**DEPARTMENT OF TRANSPORTATION****National Highway Traffic Safety Administration****49 CFR Part 571**

**Federal Motor Vehicle Safety Standards; Door Locks and Door Retention Components**

**ACTION:** Final rule; response to petitions for reconsideration; technical amendments.

**FIGURE 7 • VEHICLE COORDINATE REFERENCE SYSTEM FOR INERTIAL TESTING**

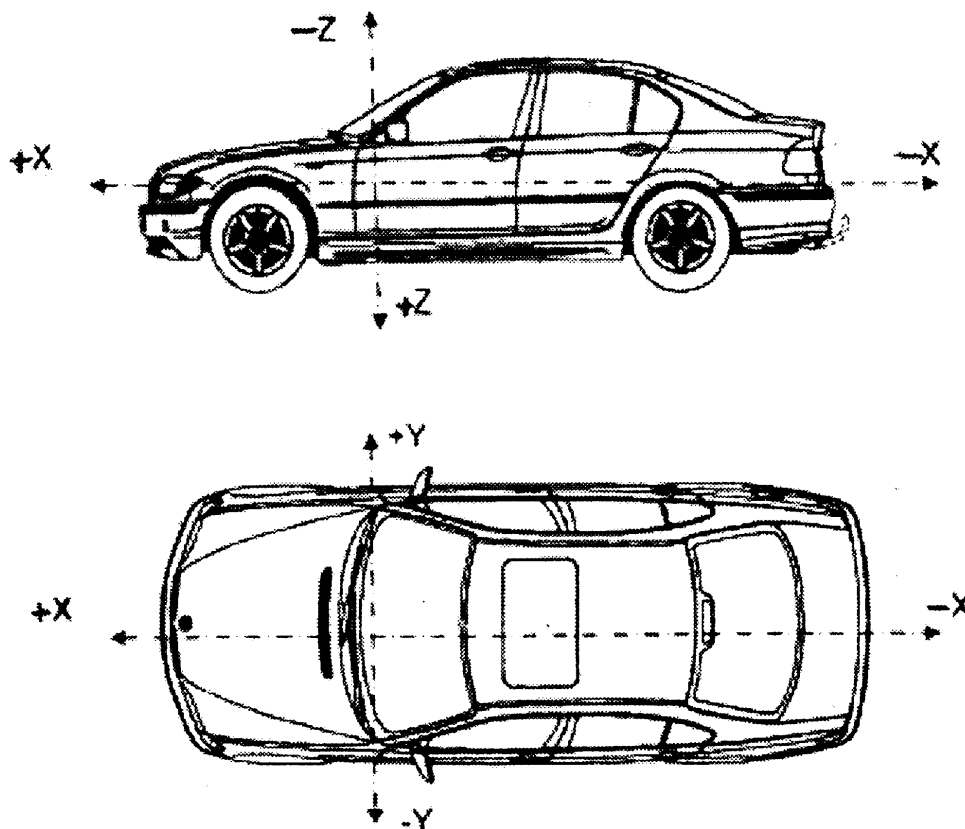
##### *b. Technical Amendment to Figure 7*

Prior to the February 2007 final rule, FMVSS No. 206 did not have a figure that graphically displayed the vehicle coordinate reference system to be used for inertial testing. The GTR provided such a figure because part of the GTR referenced various directions with respect to different vehicle axes. The NPRM proposed, and the February 2007 final rule adopted, this same GTR figure as Figure 7.

Although the agency did not receive any comment regarding Figure 7 in response to both the NPRM and the February 2007 final rule, after publication of the final rule NHTSA realized that x-axis and the z-axis in Figure 7 were not consistent with SAE J211 (Instrumentation for Impact Test) or with the sign conventions used in other Federal motor vehicle safety standards such as FMVSS No. 208 and FMVSS No. 214. Therefore, NHTSA is making a technical amendment to FMVSS No. 206 by modifying Figure 7 to be consistent with SAE J211 and the sign convention for other Federal motor vehicle safety standards as follows:

**X = longitudinal direction**  
**Y = transverse direction**  
**Z = vertical direction**
